**TOWN OF FAIRFAX
STAFF REPORT
Department of Planning and Building Services**

TO: Fairfax Planning Commission
DATE: March 21, 2019
FROM: Linda Neal, Principal Planner
LOCATION: 251 Scenic Road; Assessor's Parcel No. 001-121-50
ZONING: Residential Single-family RS-6 Zone
PROJECT: Single-family residence
ACTION: Hill Area Residential Development, Design Review, Encroachment, Combined Side-yard Setback, and Parking Variance permits; Application # 19-06
APPLICANT: Bryan Murdock, Murdock Architecture
OWNER: David Boesel
CEQA STATUS: Categorically exempt, sections 15303(a), 15305(a) and (b)

**251 SCENIC ROAD
ASSESSOR'S PARCEL NO. 001-121-50**

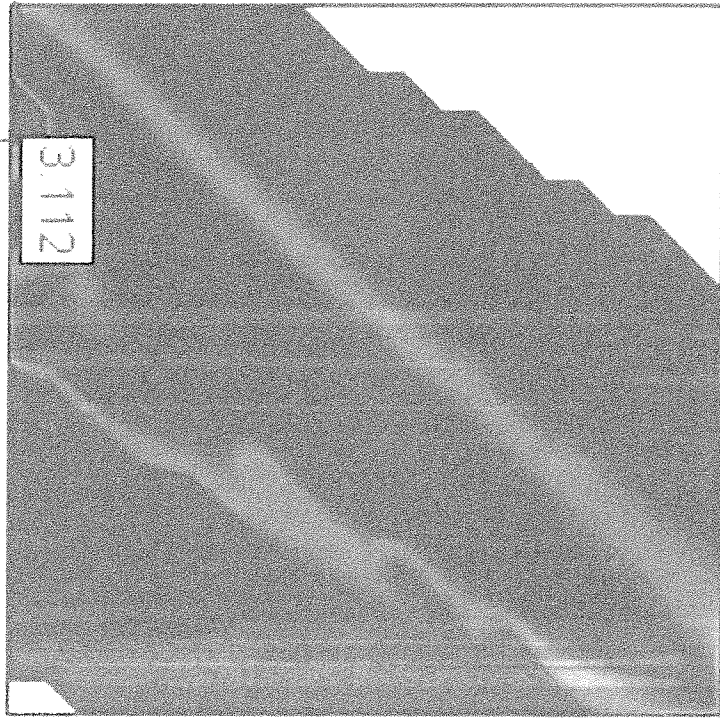
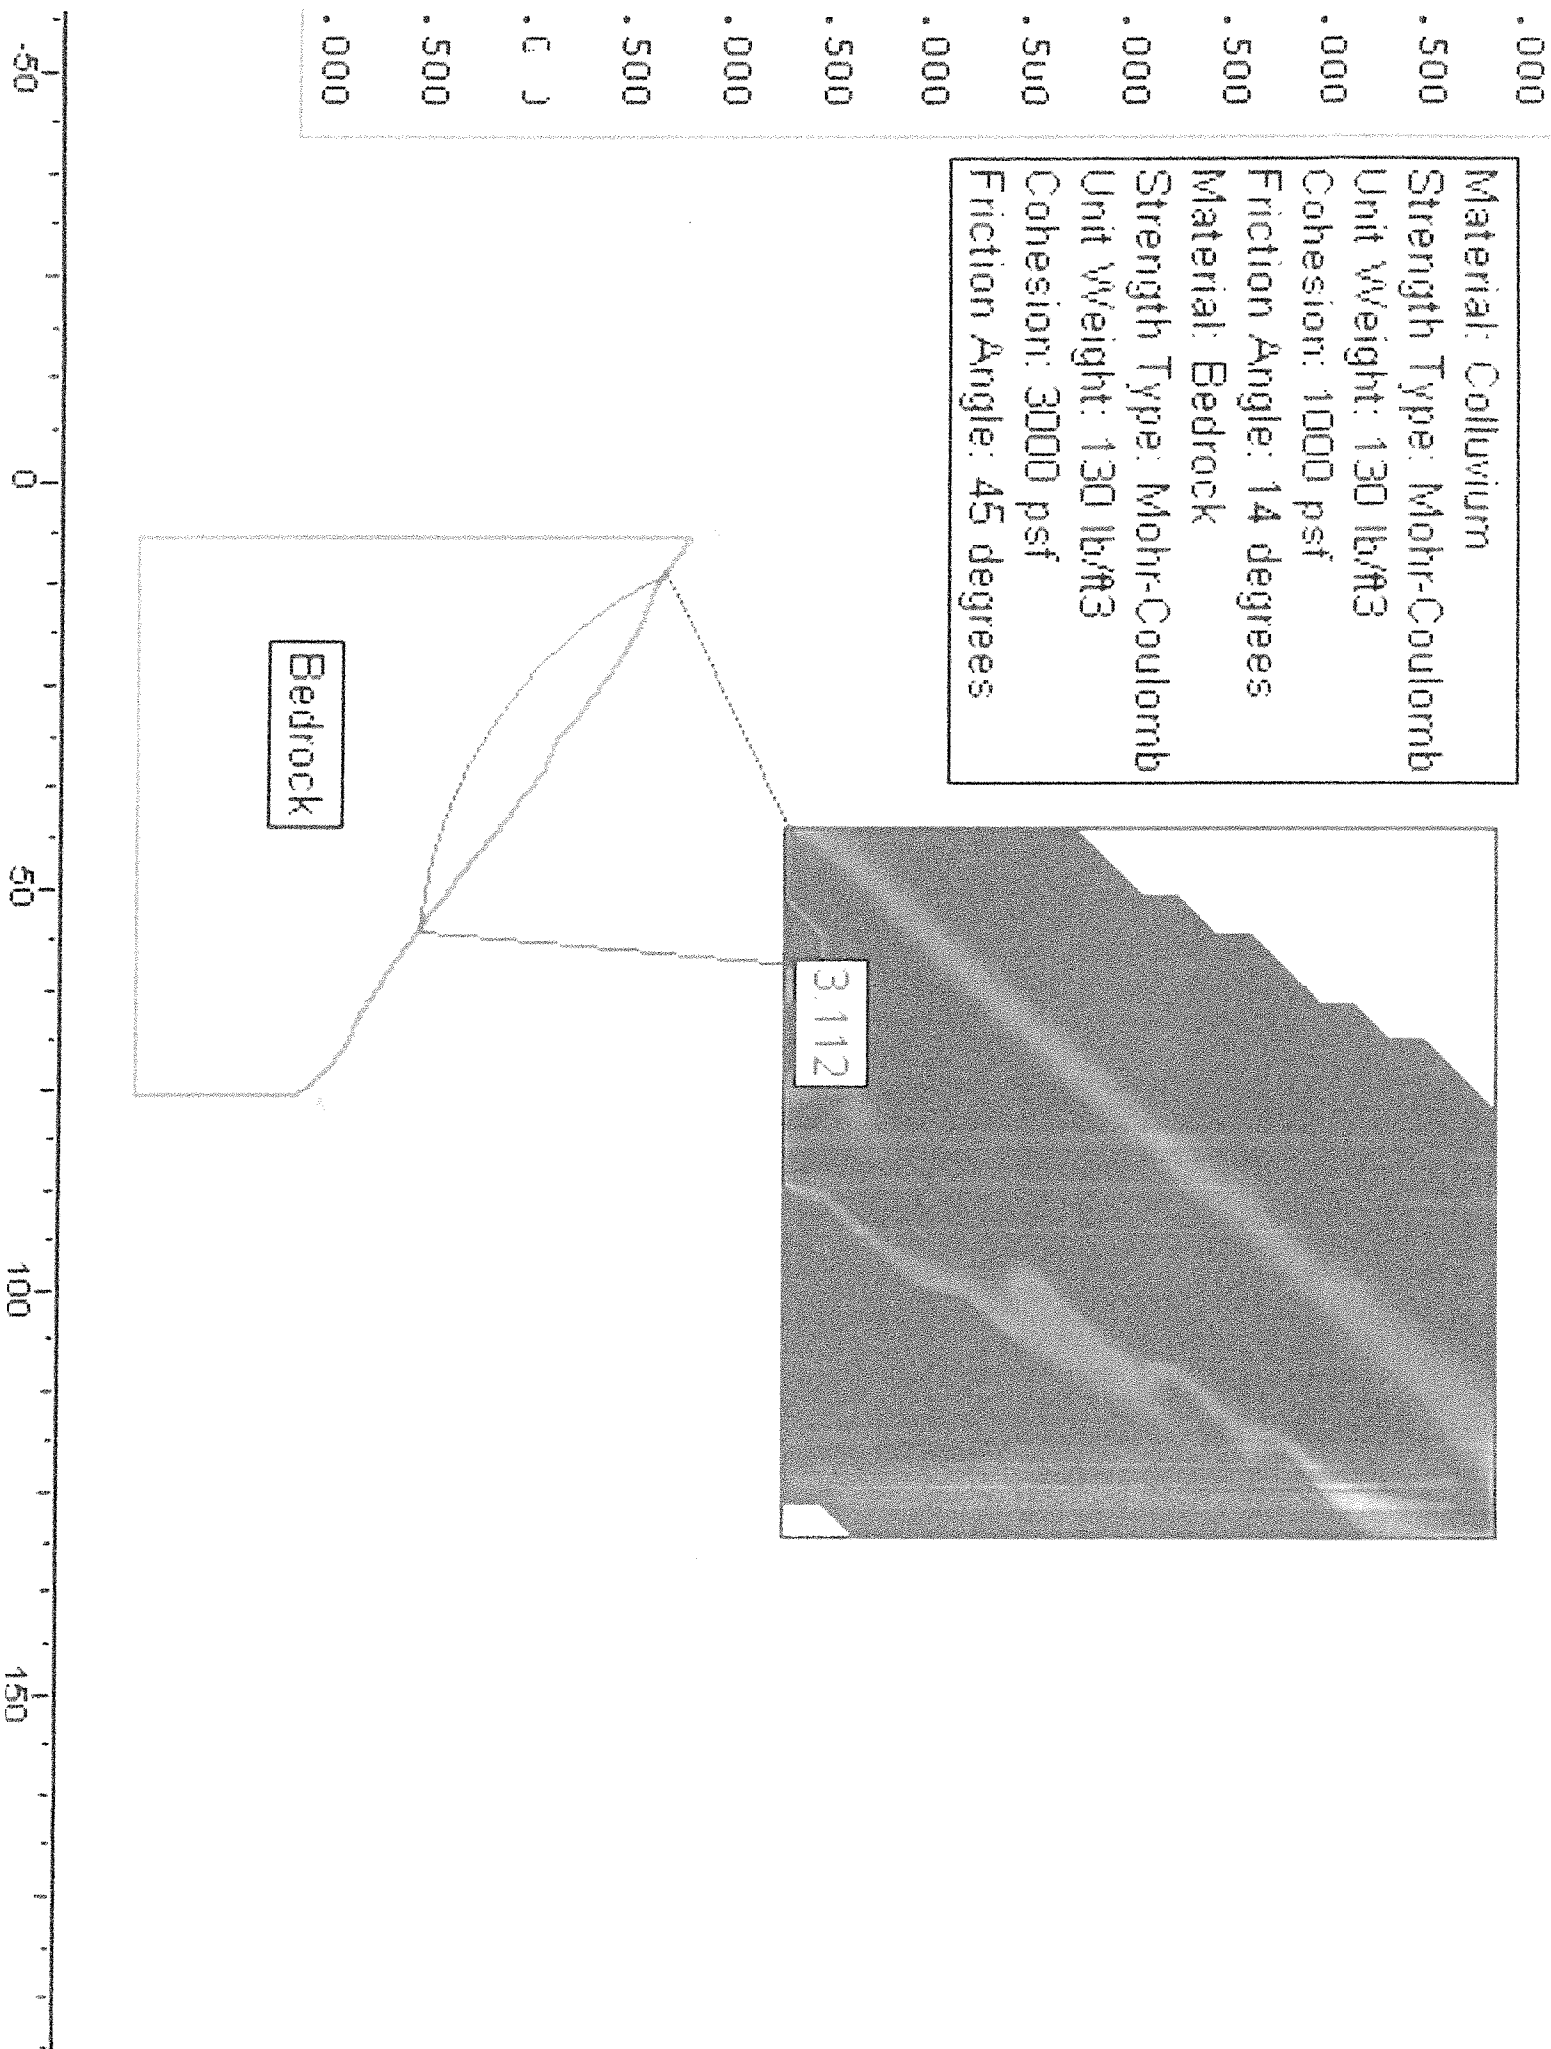
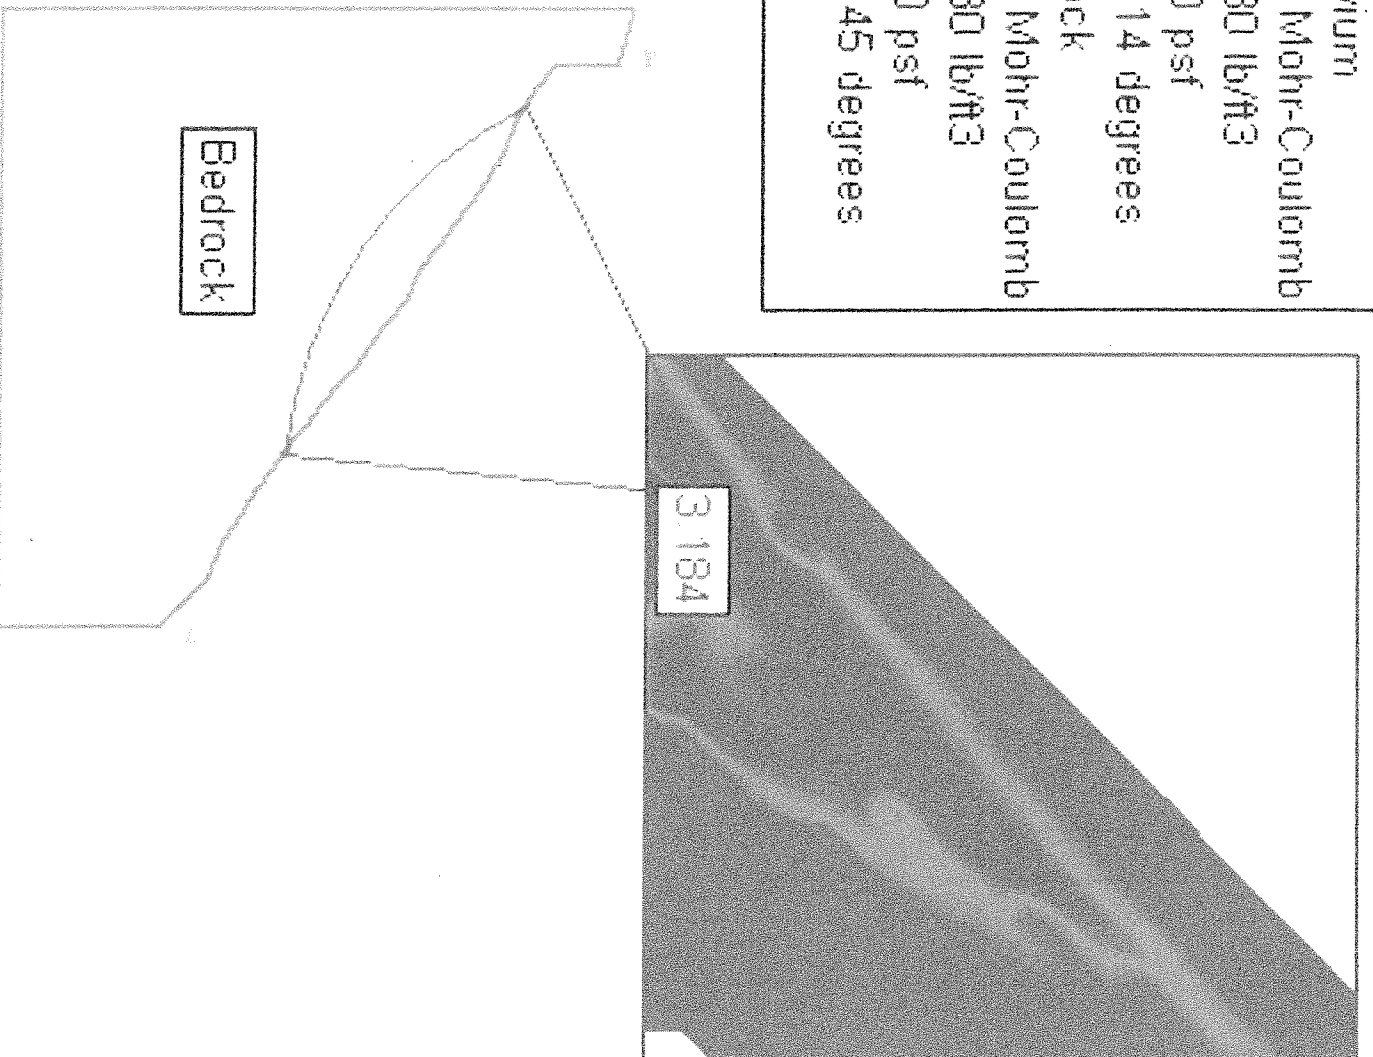
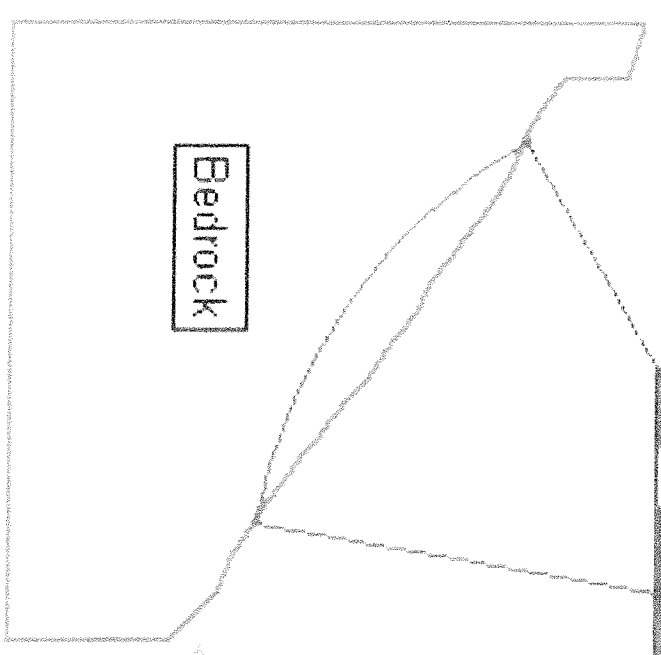
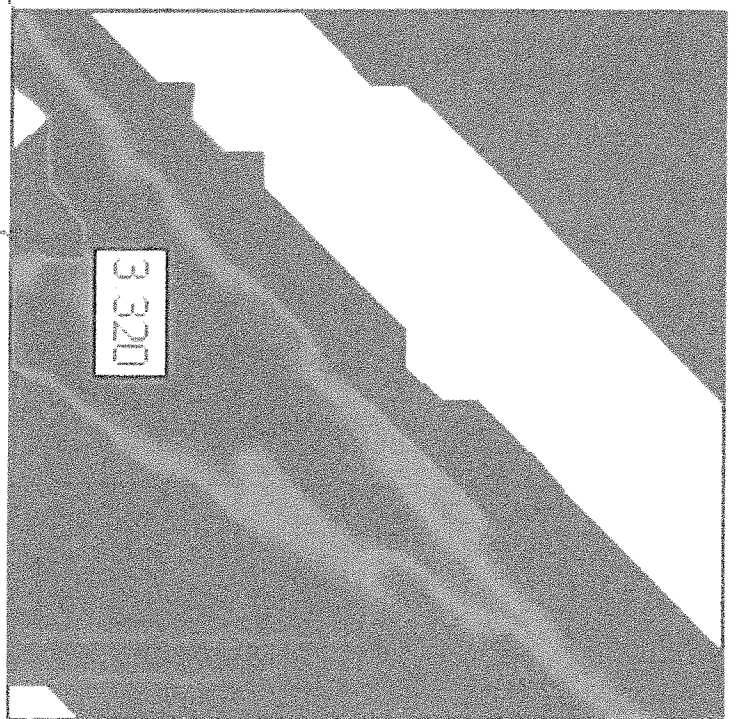
5. We understand from Salem Howes' response that the earlier slide which affected Scenic Road and resulted in construction of the exiting bin wall occurred in 1986. From the original project geotechnical report, we understand "the latest slide occurred at an unknown site and forced a downslope residence to be condemned" _ Our review of site conditions and of the Site Plan included in the project report suggest that this "latest" referenced slide originated at the location of the scarp below the planned residence. in the vicinity of the planned drainage dissipater. The provided slope-stability analyses do not indicate the presence of landslide debris at the site, although the site plan indicates "hummocky topography". Based on apparent site history and review of the boring logs, we judge it is likely some or all of the soil materials onsite are in fact the debris of a previous landslide, as opposed to colluvial or residual soils. The provided analyses utilize soil properties apparently developed via correlation with SPT blow counts. Please provide documentation of such correlations between SPT blow counts and the friction angle, strength, and cohesion values used in the analysis. If none can be provided, please provide updated analyses which utilize soil parameters developed on the basis of laboratory testing of onsite samples, or via back-calculation of previous landsliding at the site. The provided analyses are based on a model

which appears to extend 75 linear feet, while the parcel is 125-feet long. Please revise the model to accurately reflect site conditions and encompass the entire parcel. The model must show the existing roadway and bin wall, the proposed grading/structural improvements, the location of the upslope and downslope property lines, and the location of the existing slide scarp in the lower portion of the property. The model must be extended beyond the lower property line as needed to evaluate possible offsite impacts of the new development. The model must consider the phreatic (groundwater) surface and be evaluated under both static and seismic conditions.

We have attached some Rockslope® models with parameters obtained from the SPT with varying parameters and found adequate slope Factors of Safety. If MPEG can provide an analysis that indicates the slope is unstable we will be pleased to consider it.
